**Addendum No. 2**  
**Page 1 of 2**

**TO:** Prospective Bidders  
**SUBJECT:** Addendum No. 2  
**PROJECT NAME:** City Center Site Work  
**JJC PROJECT NO.:** B20045

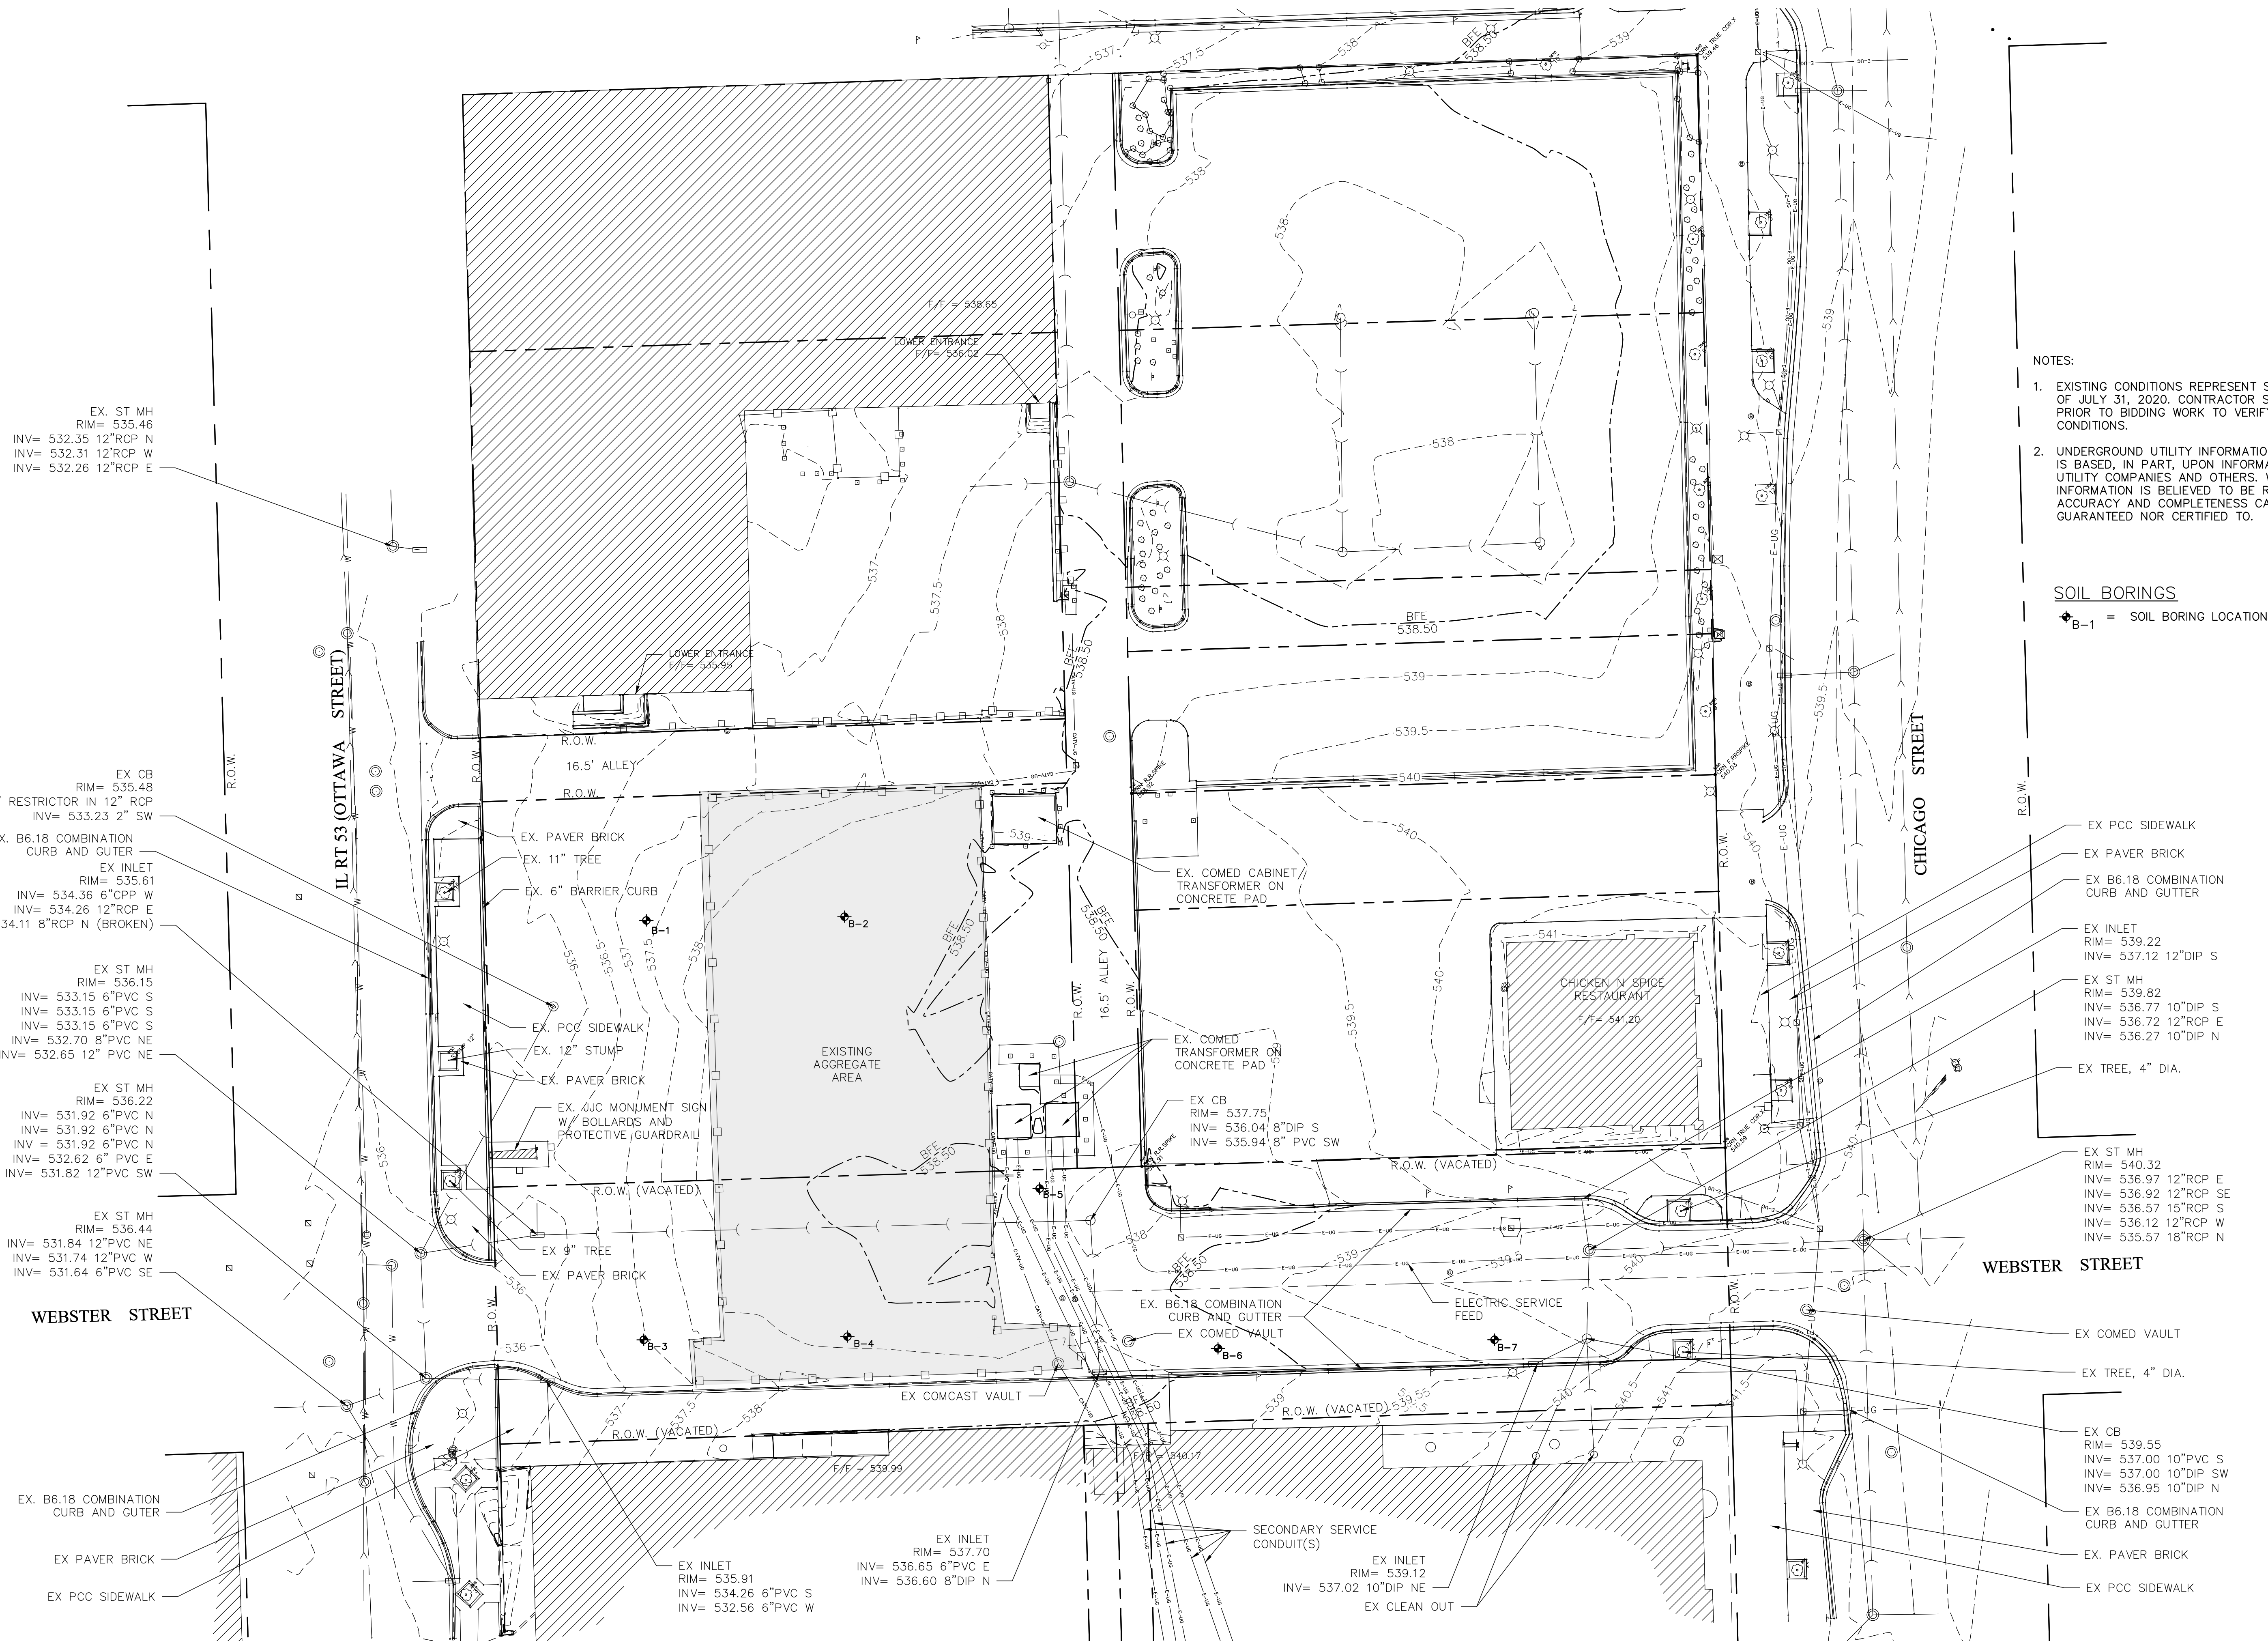
1. General All plan sheets bear a revision date of 4/12/2021, Addendum 2
2. Sheets 1-2/18 No further revisions
3. Sheet 3/18 Revision of quantities for items 38, 39, 40, 52, 53, 54, 55, 56, 57, 59, 60, 61

SCALE	1"=20'
DATE	2-1-2021
DESIGN	JTS
CHECKED	HJH
DRAWN	DWS
PROJECT NO.	20904
SHEET	15 OF 18

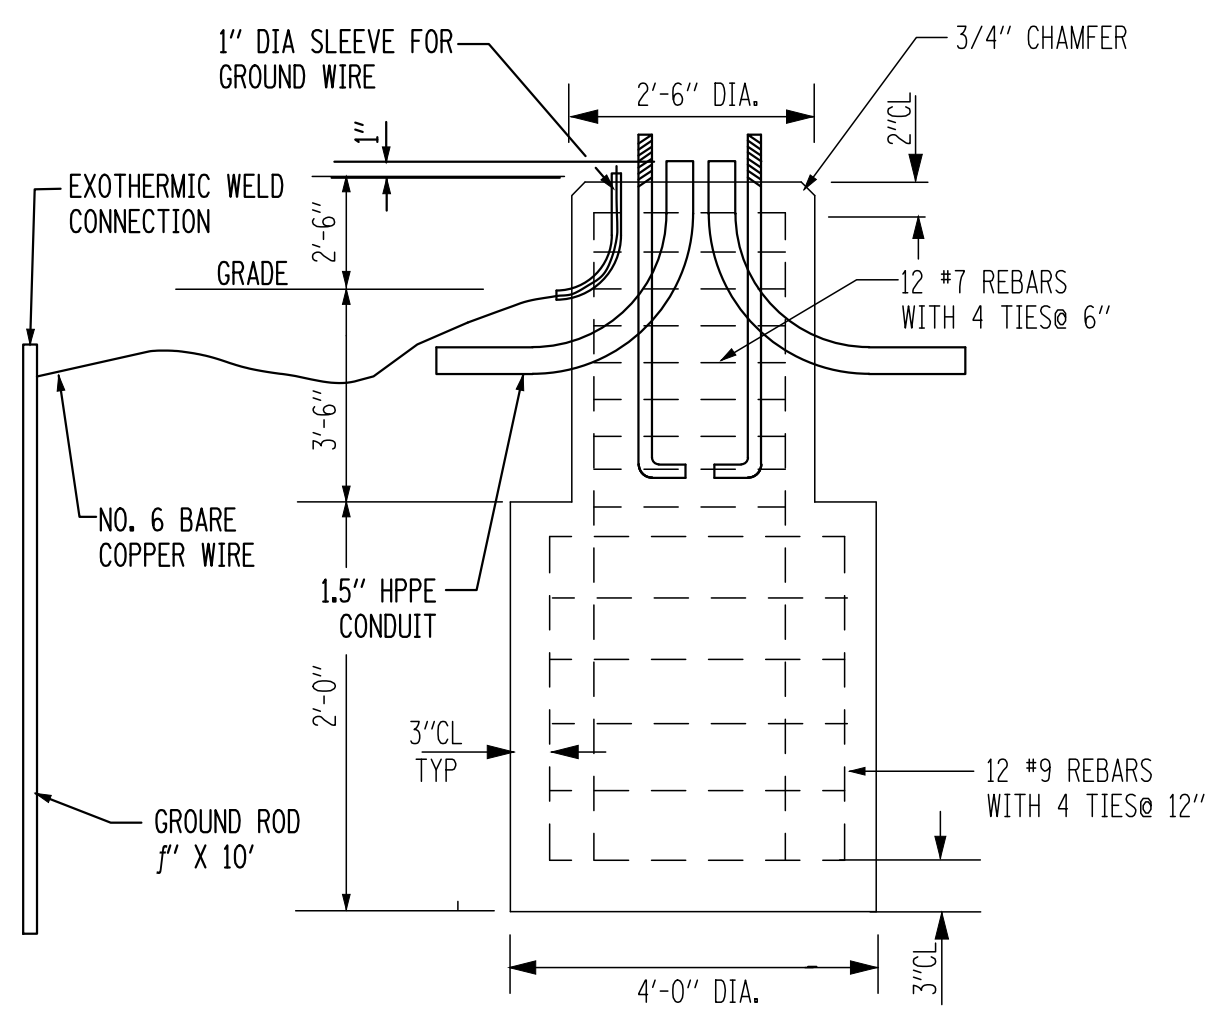
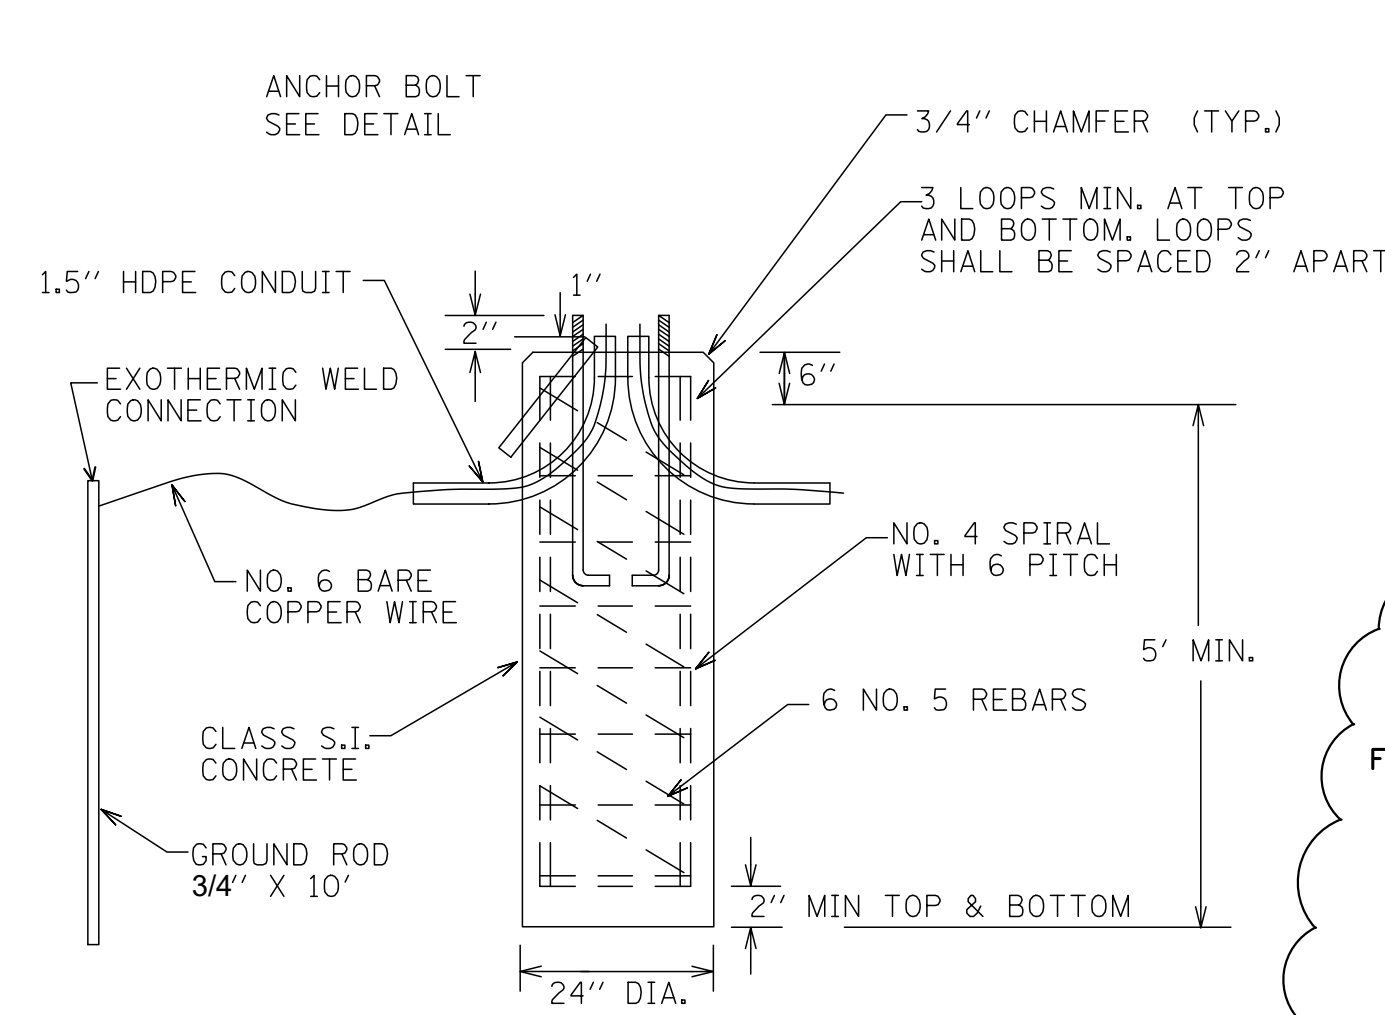
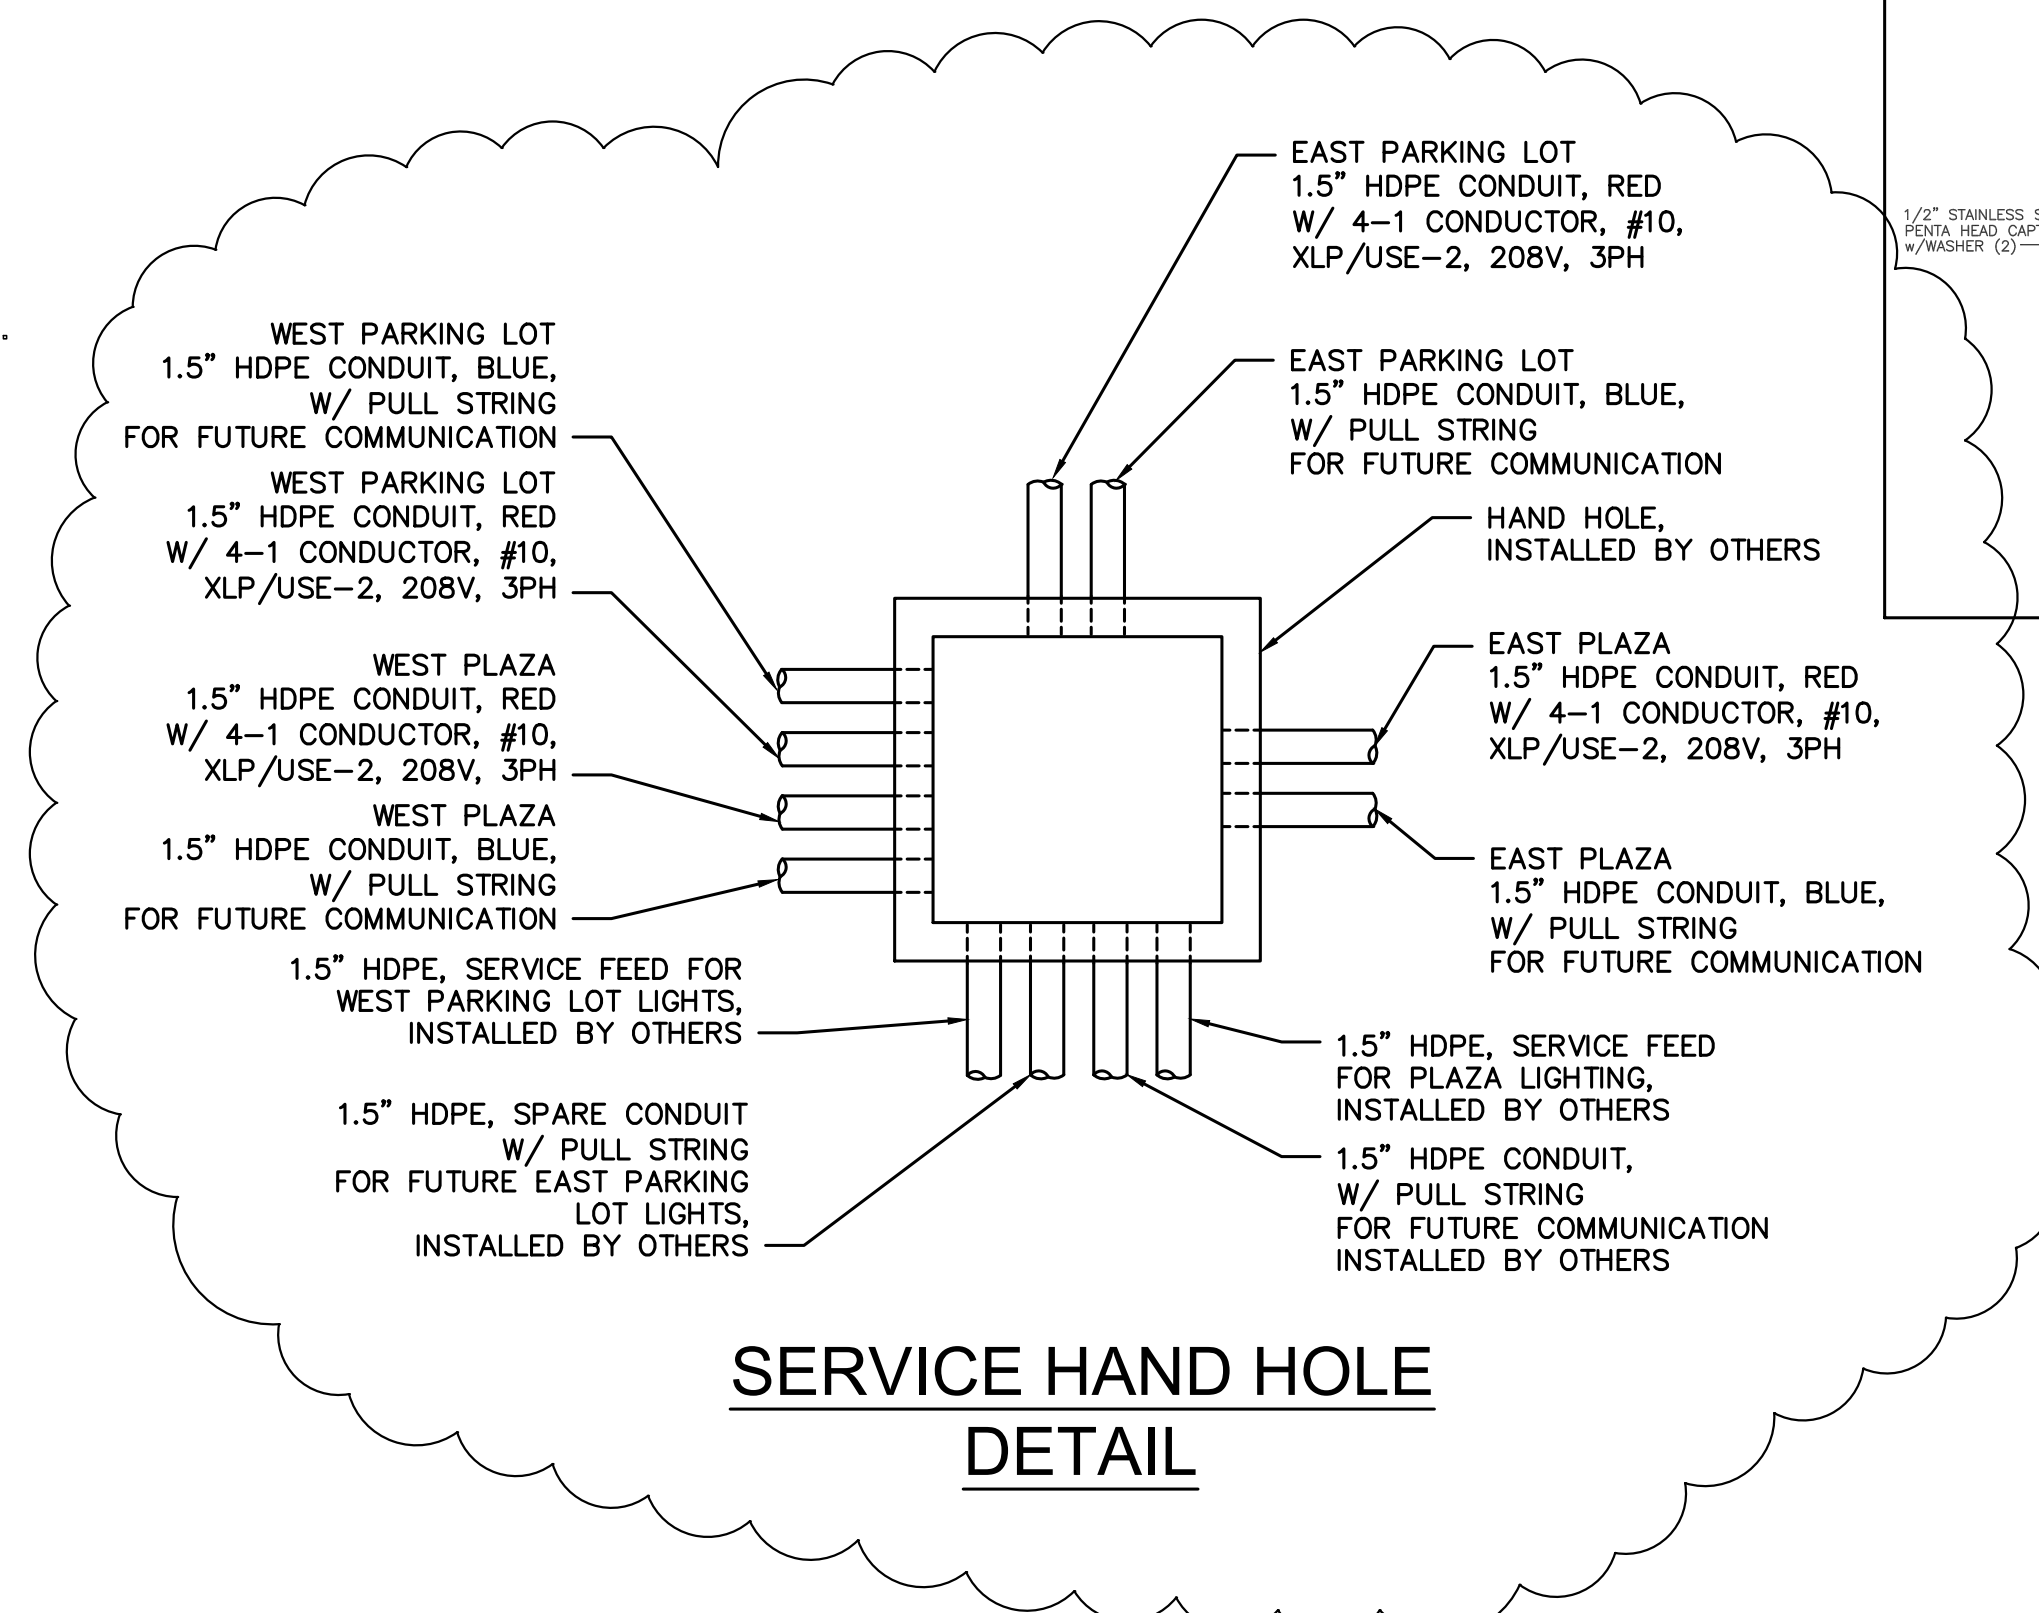
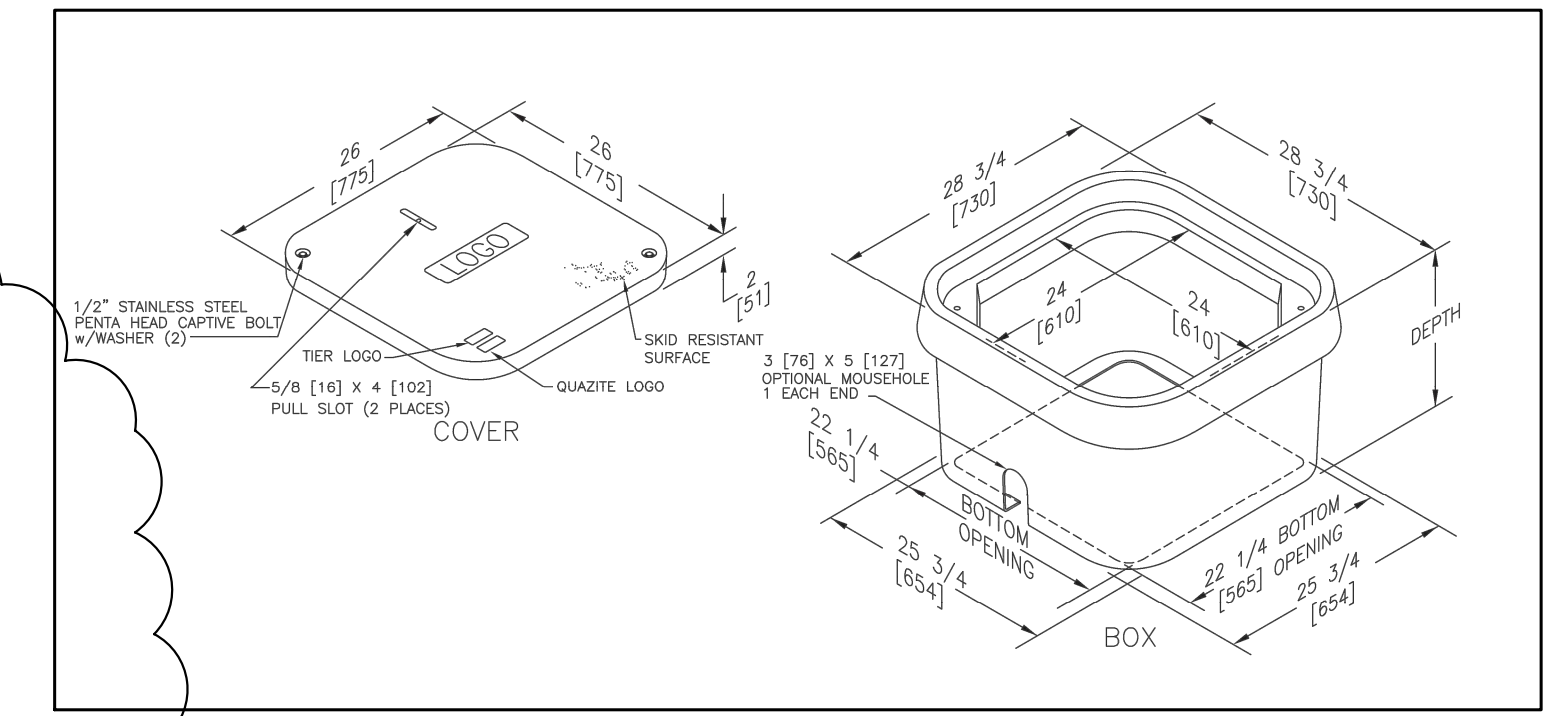
9. Sheet 12/18 The restrictor manhole has been modified per IDOT request
10. Sheets 13-14/18 No further revisions
11. Sheet 15/18 Additional parking lot lights, including conduit revisions

- i. The electrical service handhole has had details added
12. Sheets 16-18/18 No further revisions
13. Sheets L1-L3/L3 No further revisions
